SITE DEVELOPMENT PERMIT

FILE NO SDP19-00001

EVERGREEN FORD LINCOLN DEALERSHIP

STAFF REPORT

Figure 3: Connection from main site entrance to the regional Issaquah-Preston Trail

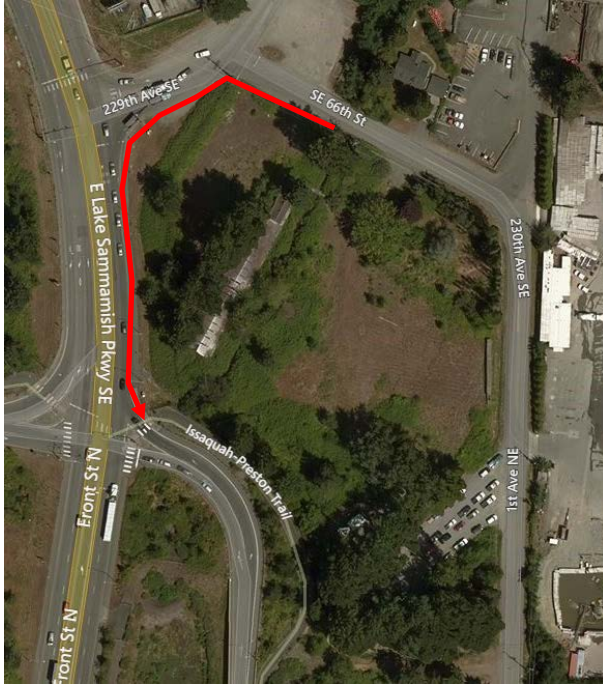
Complies, with condition - The Issaquah-Preston Trail borders the site to the southwest (see photo below). Direct connection to this trail is not possible through the WSDOT right of way. The nearest connection from the main site access point (at 66th Street SE) is to travel from northwest on SE 66th Street, then southwest on 229th Avenue SE, and then south on E. Lake Sammamish Parkway SE. This route is approximately 770 ft. away.

Condition 3: *The project shall include signage onsite near the site access at streets bordering the site, including at 66th Street SE and East Lake Sammamish Parkway, directing users to the nearest connection with the Issaquah Preston Trail.*

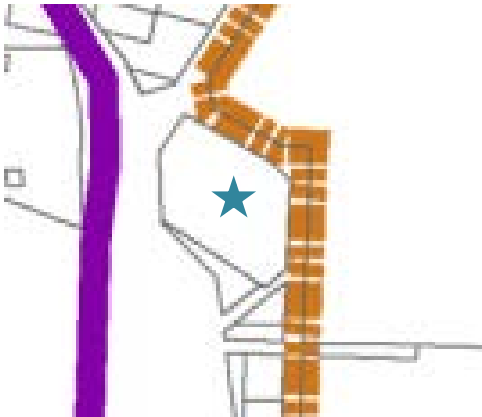
The applicant did not provide a detailed street section or information on paving, bollards, or lighting. This additional information will be required with construction permits.

Condition 4: *Prior to site work permit approval, the applicant shall submit detailed plans showing how the private pedestrian priority street will comply with CIDDS 6.4.D.*

Figure 7. Highlighted area of SE 66th Street where applicant proposes removal of landscape strip.

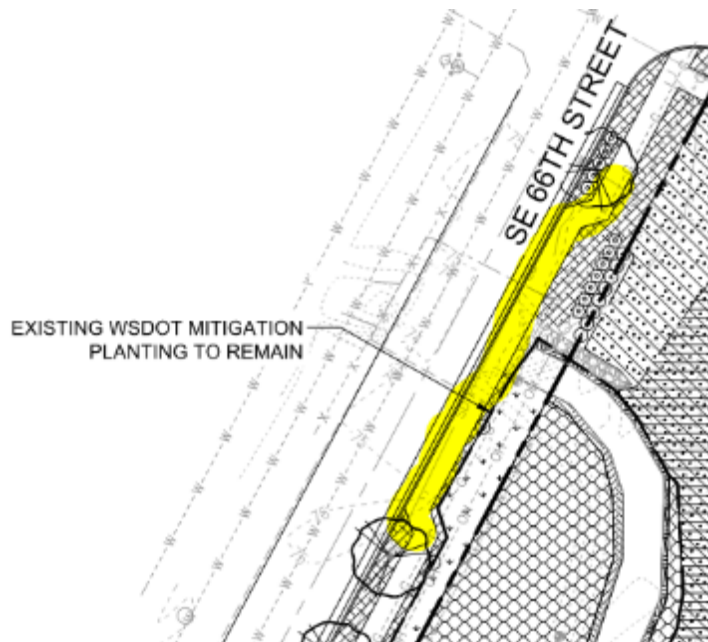
For most of the frontage along SE 66th Street, improvements comply with T-12 Street Standard for Collector Street/Arterial. At the point where SE 66th Street crosses the North Fork of Issaquah Creek; however, the landscape strip has been removed. As this is a City Street Standard, the change to the standard is processed as a deviation. This is processed outside of the commission process.

Above: proposed revisions to the CIDDS Boulevard Standard

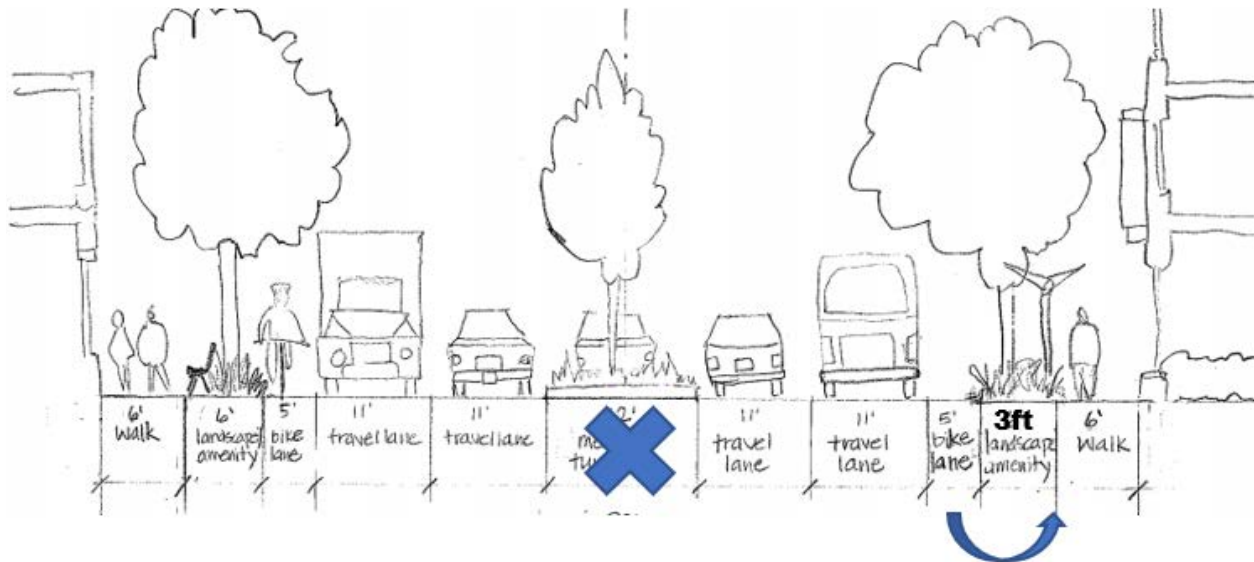
The proposed improvements modify the standards at CIDDS 6.4.G. Therefore, the following Administrative Adjustment of Standards is requested.

Request: Modify the Boulevard standard to allow the bike lane behind the curb and reduce the landscape amenity:

Condition 5: To implement this shared facility, bicycle and pedestrian facilities will have distinct surface materials with signage and/or striping to identify each user's zone: Asphalt for bicyclists, Concrete for pedestrians. Street trees will not be planted.

Figure 10. Two driveway locations at 230th Ave. SE. The driveway to the left serves as an entry for automobiles, whereas the driveway to the right will serve primarily trucks.

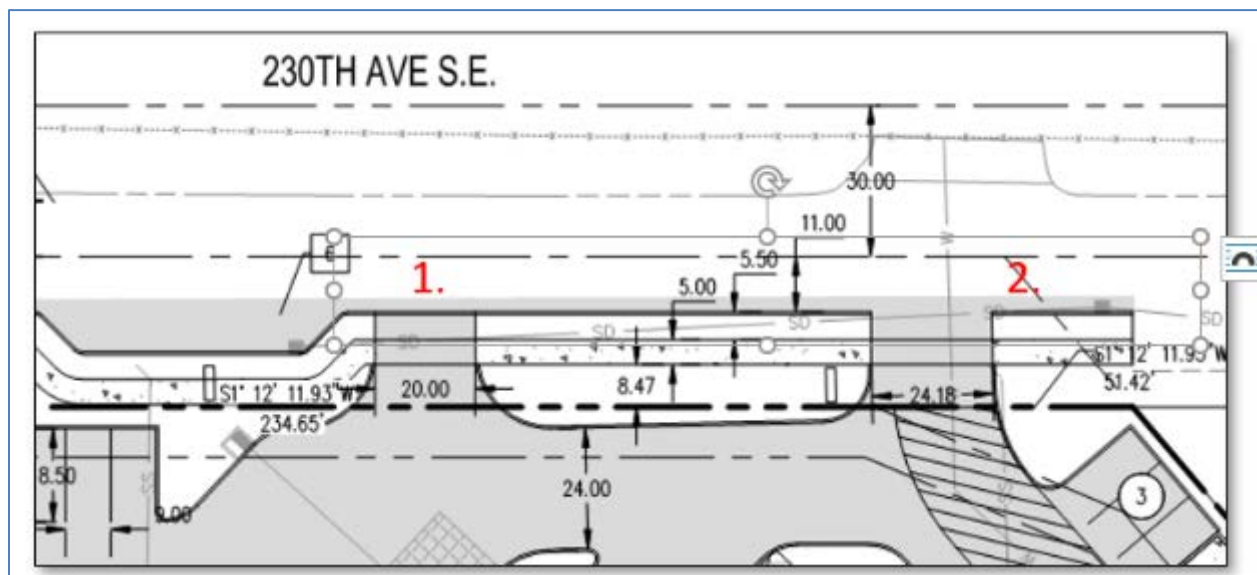
Driveway #1 does not meet the City's Street Standard for access point spacing and shall be consolidated with Driveway # 2 below.

Condition 6: *The northernmost driveway on 230th Avenue Southeast does not meet the City's street standard for access point spacing. Prior to site plan approval, site circulation shall be reconfigured to meet city access point spacing standards.*

Figure 11. Parking landscape plan. Note the area outlined in red is part of the private road frontage and does not count toward the total parking lot landscaping requirement.

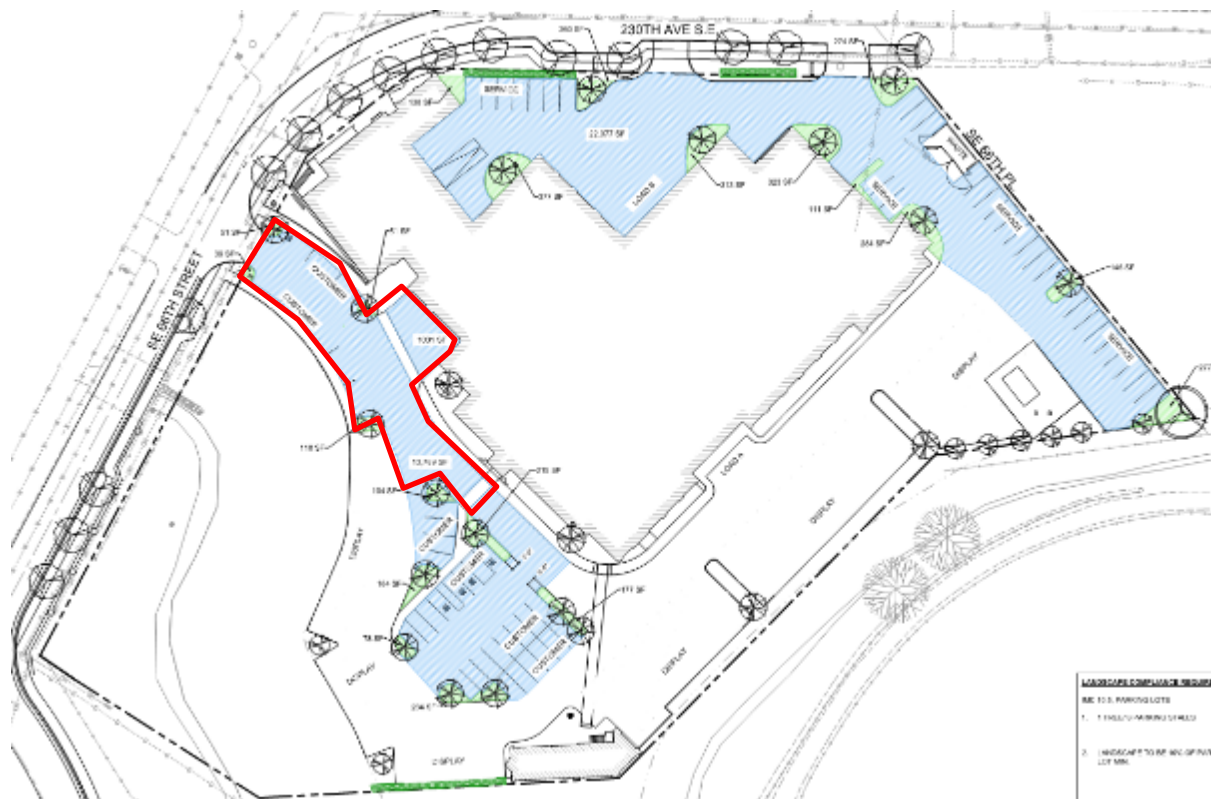
Parking Landscape Plan, excerpted below, demonstrates compliance with these standards. An area shown in a red box should be excluded from the parking lot landscaping calculation, since it is part of the Pedestrian Priority street area; however excluding this area does not impact compliance. The applicant's calculations are provided below, though these should be updated in the final landscape plans to exclude the Pedestrian Priority area.

Figure 12: Rooftop landscaping plan

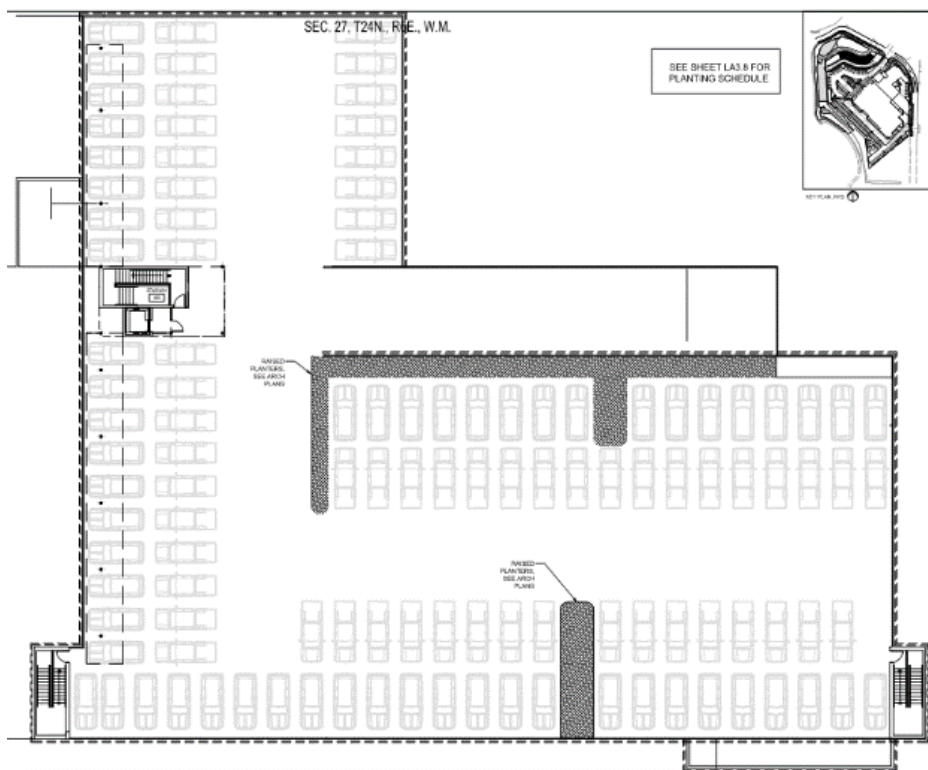
canopy along the northwest side of the roof and above an adjacent elevator area. Raised beds are located primarily in the interior of the site. It is unclear whether the rooftop landscaping meets the requirement that “architectural elements or landscaping shall provide a visual screen at least 3 ft. in height around the entire perimeter of the rooftop.” No dimensions are provided for the parapet wall height. Additionally, area calculations were not provided, nor were specific details on the raised planters or glass canopies. The proposed designs are acceptable at this level of review, but additional details will be required with landscape plans to demonstrate compliance with 10.5.B.2 .

Condition 11: *In accordance with CIDDs 10.5.B.2, the applicant shall provide details for landscaping and architectural elements to show compliance with rooftop landscaping requirements.*

Figure 14. Buffer impact and mitigation plan

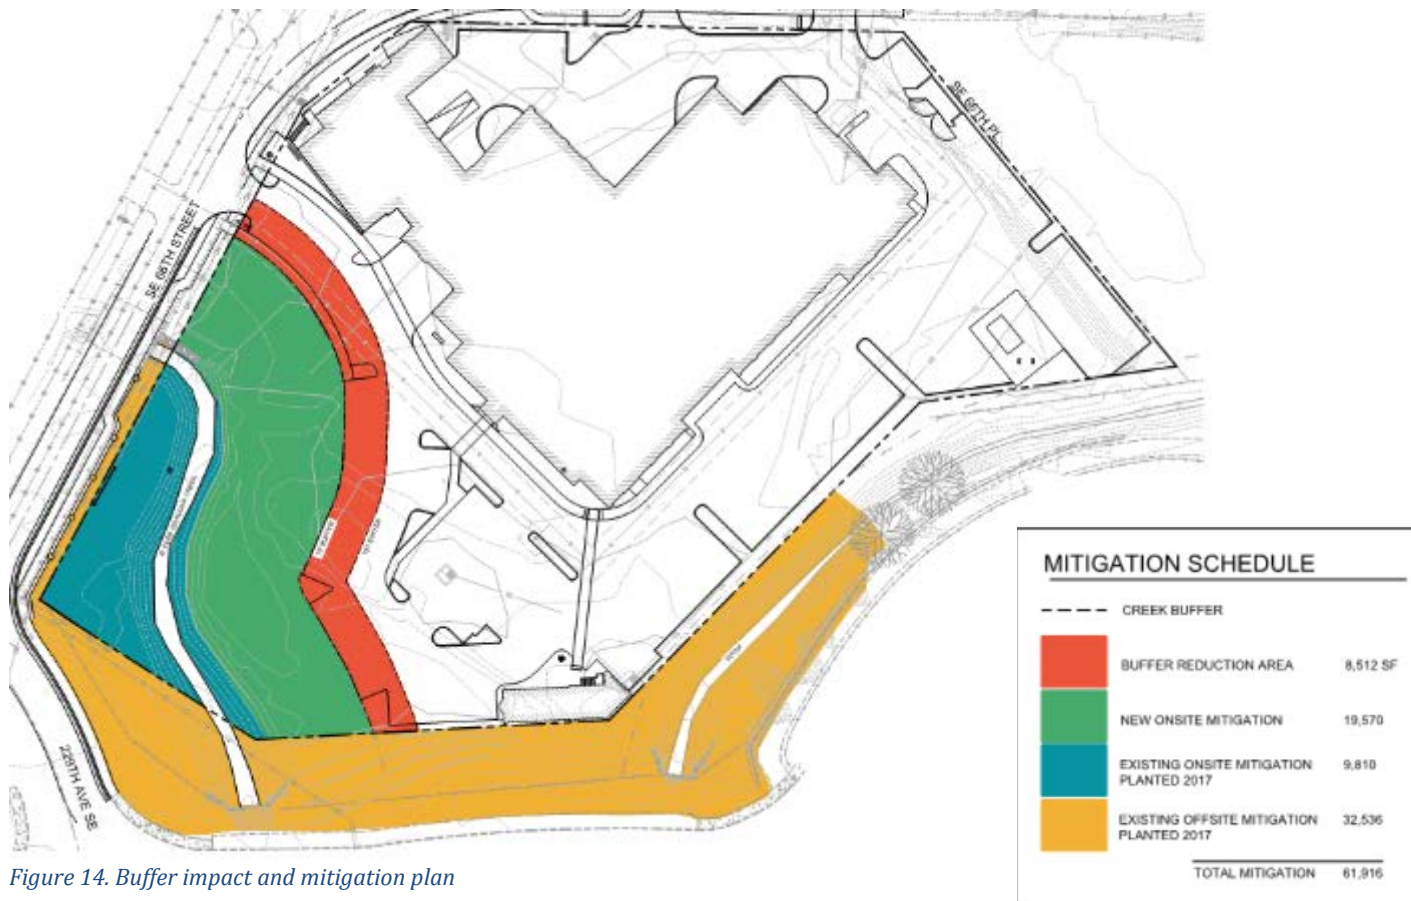
Overall, the proposal aims to improve water quality and habitat function of the North Fork Issaquah Creek through the addition of native vegetation and woody debris to the creek and its buffer. Additionally, the applicant proposes sloping adjacent new impervious surfaces away from the critical area so as to prevent the diversion of stormwater runoff into the creek. However, the applicant, via their and the City's consultants, is required to confirm that planting in the Existing Onsite Mitigation (2017) area complies with City requirements. If it does not, additional or revised planting will be required.

Condition 12: *Confirm that planting in the Existing Onsite Mitigation area complies with City requirements. If the planting schedule is found to be noncompliant, then additional or revised planting shall be required.*

East Lake Sammamish Parkway (north to left):

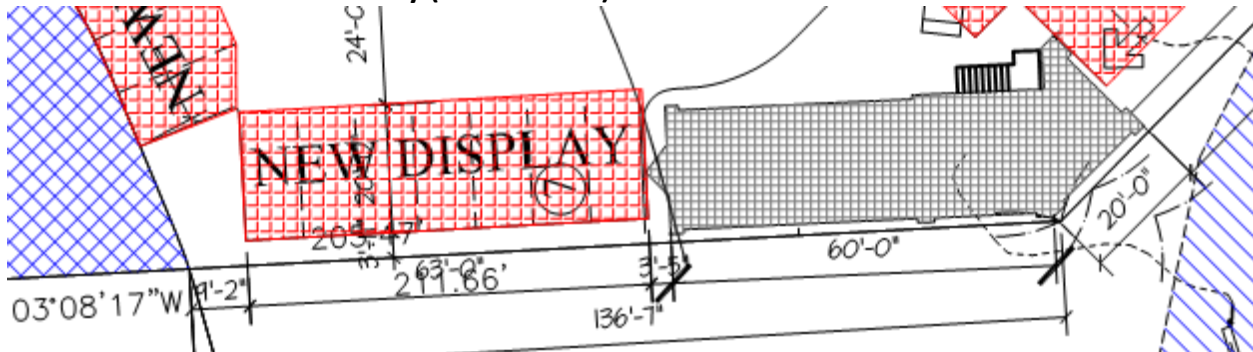
Overall length:	136 ft. 7 in.
Minimum Build to length compliance:	60%
Required:	82 ft.
Provided:	60 ft.

Condition 13: The East Lake Sammamish Parking way frontage must provide an addition 12 ft. of Alternative Building Frontage elements, i.e., architectural elements, that comply with CIDDS 11.3.J to fulfill the remaining Build-to-Line requirement.

11.3H Corner Building Frontage

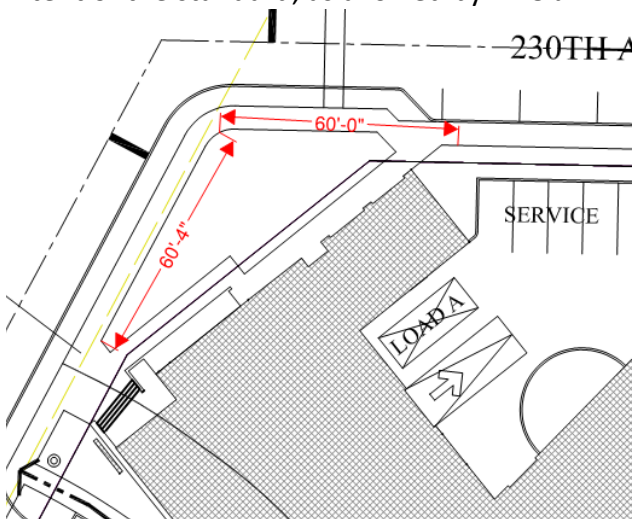
As the north portion of the building is located at the intersection of Circulation Facilities, CIDDS 11.3.H applies and requires that a minimum of 60 ft. of building frontage be provided as measured from the corner of the intersection. As shown below, building mass is not present at the intersection and the building does not occupy all the build-to-line for at least 60 feet from the intersection. There is a concern that sight distance could be blocked if the building occupied the corner build-to-line. Alternative building frontage should be added to this area to meet the intent of the standard, as allowed by 11.3.J.

Condition 14: *Alternative building frontage must be added to the corner of SE 66th Street and 230th Ave SE in order to comply with the intent of 11.3.H Corner Building Frontage.*
